BULLETIN NO. 231110

**PRODUCT:** 2021 UH15B K-Series

**TITLE:** Pilot adhesive change

MODELS AFFECTED: UH15B-060K thru UH15B-235K

Photo 1: Original location of adhesive

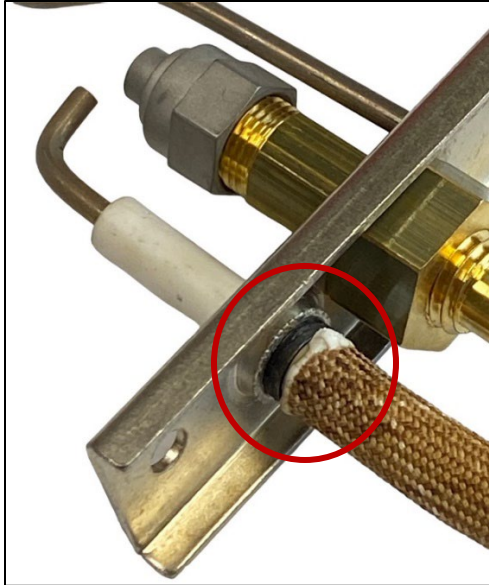
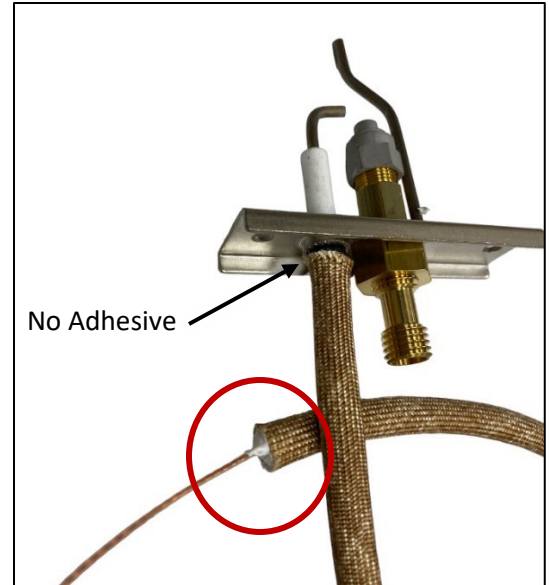
Infrequent field reports of nuisance failures associated with the UH15B-K series boilers has prompted a change to the pilot assembly. The change eliminates any potential for electrical continuity created by the adhesive that holds the fiberglass sleeve in place. Electrical continuity in the area of the pilot ignitor can interfere with the flame rectification circuit and cause a nuisance shutdown.

To prevent any possible electrical continuity between the ignitor and ground the adhesive used to hold the fiberglass sleeve in place has been moved from the ignitor to the other end of the sleeve. This was a rolling change implemented in March of 2023. See photos 1 & 2.

1. Temporary fix: Roll back the fiberglass sleeve and remove the adhesive. The adhesive can be removed by scraping it away. Use a wire tie at the opposite end of the fiberglass sleeve to hold it in place so that the pilot end covers the igniter.

2. Permanent Fix: Replace the pilot assembly, kit no. 550003793. Ensure the new pilot does not have adhesive on the igniter end of the fiberglass sleeve.
